UNITED STATES PATENT AND TRADEMARK OFFICE

Office Action Summary

10/777,264

DETAILED ACTION

FIG. 3A

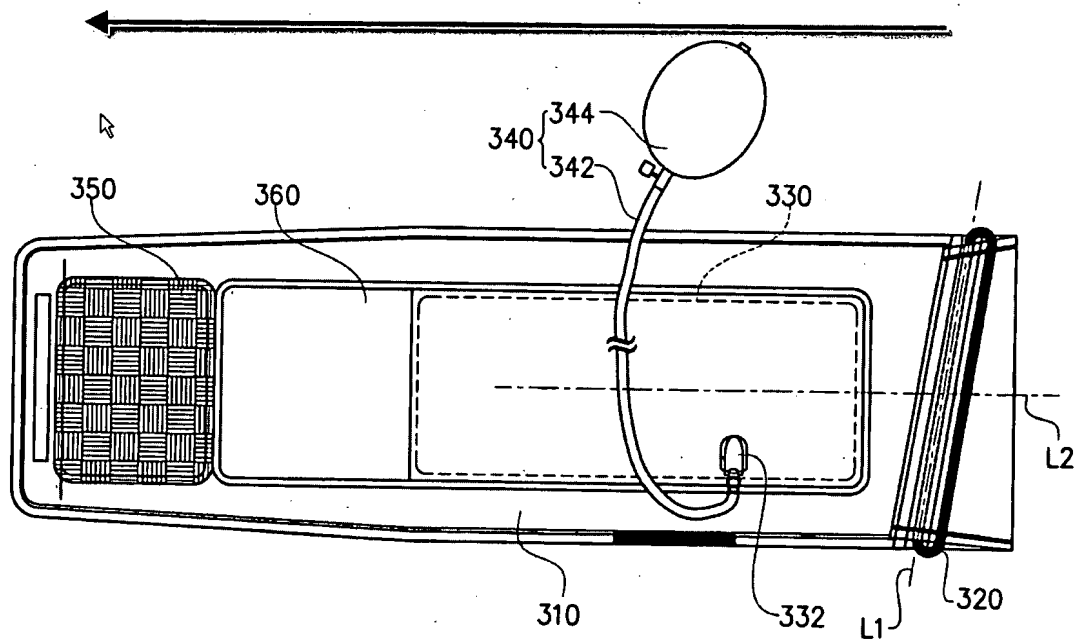
The amendment filed 7/18/07 is objected to under 35 U.S.C. 132(a) because it introduces new matter into the disclosure. 35 U.S.C. 132(a) states that no amendment shall introduce new matter into the disclosure of the invention. The added material which is not supported by the original disclosure is as follows: "strap unit 310 with a uniform width". The applicant states that the amendment to paragraph 18 is amended to include features shown in fig. 3a (see p. 6 of the remarks filed 7/18/07). Figure 3a has been reproduced below with an added arrow. Figure 3a does not show a strap unit having a uniform width, but does show a strap having strap whose width narrows slightly in the direction of the arrow. Nowhere else does the applicant's specification address the width of the strap. Applicant is required to cancel the new matter in the reply to this Office Action.

The amendment filed 7/18/07 also includes the following added material which is not supported by the original disclosure: "the strap unit 310 with . . . a free end and a folded end" and "the ring unit 320 is embedded in the folded end of the strap unit 310". The applicants cannot rely upon figure 3A to show support for this added material, since figure 3A does not clearly that the end of the strap having the ring is "folded", nor does the specification state that this end is folded. Furthermore, paragraph 24 of the specification states, "one end of the strap 310 passes through the ring and is folded back for the first adhering region 350". It appears that the end of the strap that is so "folded" is not the end having the ring. Applicant is required to cancel the new matter in reply to this Office Action.

Each of claims 1 and 5 recites "a strap unit with a uniform width". The instant specification lacks support for such a strap having a uniform width. As explained above, figure 3A of the instant application, in fact, shows the strap having a non-uniform width.

Each of claims 1 and 5 further recites, "a strap unit with . . . a free end and a folded end; a ring embedded in the folded end". The instant specification lacks support for such a strap having a folded end and a free end, wherein the ring is embedded in the folded end. While figure 3a shows the ring being embedded in an end of the strap, the end is not disclosed as being "folded" nor does figure 3a clearly show such a fold.
